ERA Ranger Tailings

Corridor Review

Sinclair Knight Merz

Sinclair Knight Merz 2000. *ERA Ranger Tailings Corridor Review*. Supervising Scientist Report 154, Supervising Scientist, Darwin.

Appendix D Corridor section

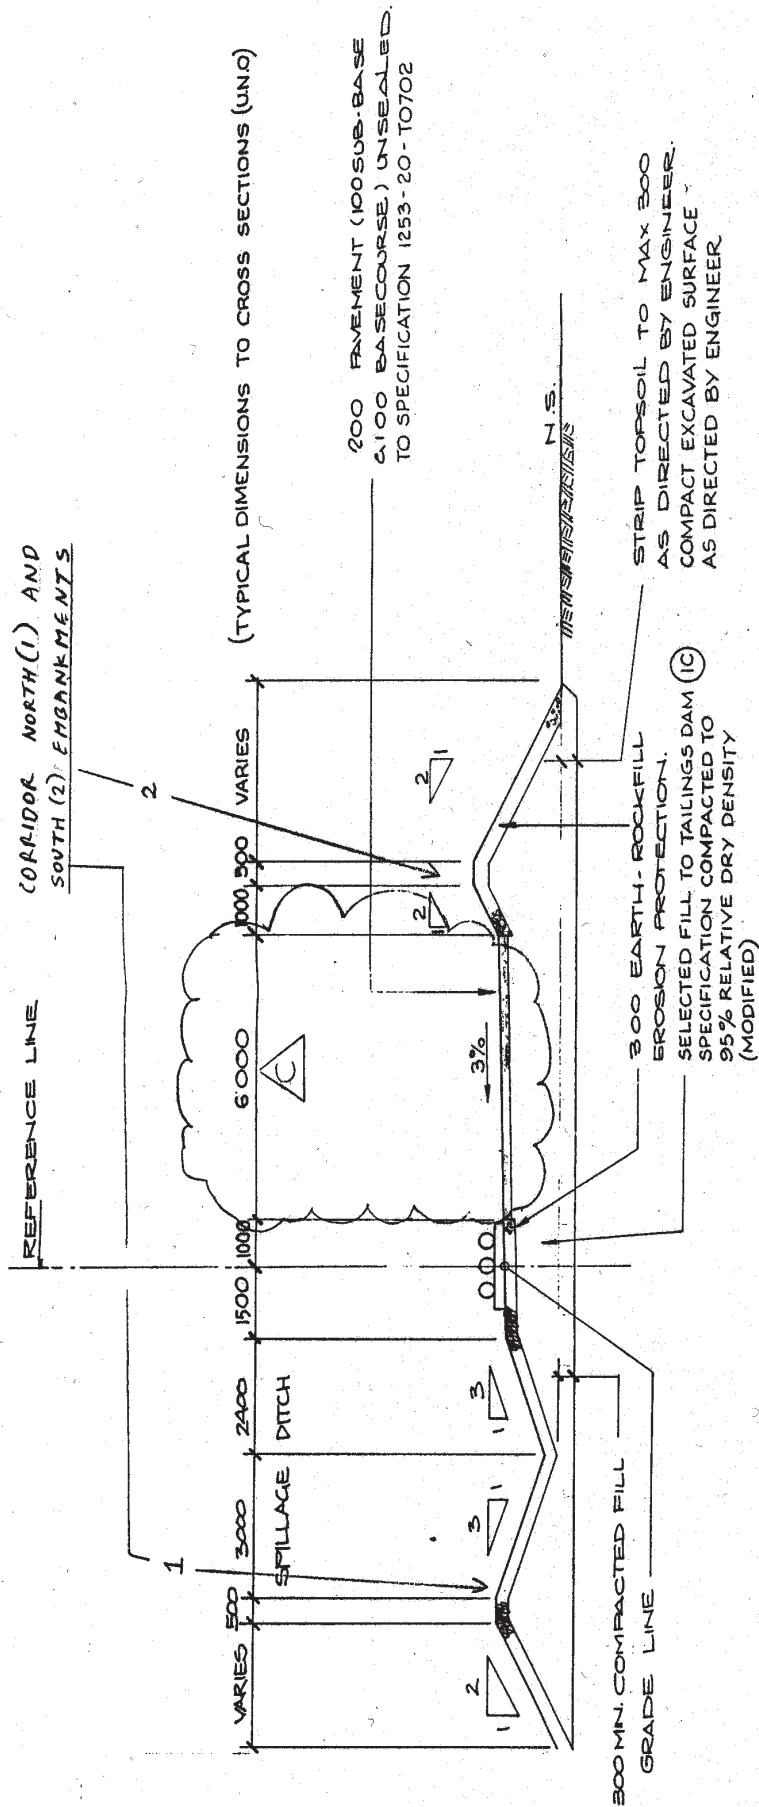
Typical cross section details from the original design are shown in drawing no 1253-04-T0039 included in appendix D. In section, from south to north, it comprised an embankment, a 6 m wide vehicle access way, a pipe track, an open drain and a further embankment. The corridor south side embankment formed the southern limit of the RRZ.

1. The 500 mm polyethylene pipes, located as they are in the corridor drain, raise the following concerns:
 - They do not have sufficient clearance between them and the corridor north side embankment to provide reasonably reliable protection against discharge of process water into the catchment areas (11A and part of 11) in the event of a leak in one of these lines. In order to overcome this, consideration should be given to appropriately increasing the width of the corridor on its north side between the Pit 1 branch corridor and the tailings dam.

- The drainage capacity of the ditch could be impeded by the pipes. This should be reviewed and the adequacy of the drainage confirmed if it is intended to leave the pipes in the drain.

- Thermal movement of the HDPE lines in the ditch could lead to progressive erosion and degeneration of the trench. General maintenance of the trench is also made more difficult by the presence of these pipes. Again, these aspects should be examined further if it is intended to leave the pipes in the drain.

- Investigate the widening of the western end section of the corridor where the 500 mm polyethylene pipes run in the drainage trench in order to reduce the risk of a pipe leak resulting in contaminated water falling outside the corridor embankment. Incorporate an examination of the other potential impacts of the polyethylene pipe routing noted in this report as part of the review.
- Obtain and review the particle grade and impermeability etc specifications for all main and branch corridor coverings to confirm their acceptability with respect to prevention of seepage/leakage from the corridor.
- Specifically review all areas where the original corridor base material has been significantly disturbed/alterd to ensure that the cover now provided is adequate.
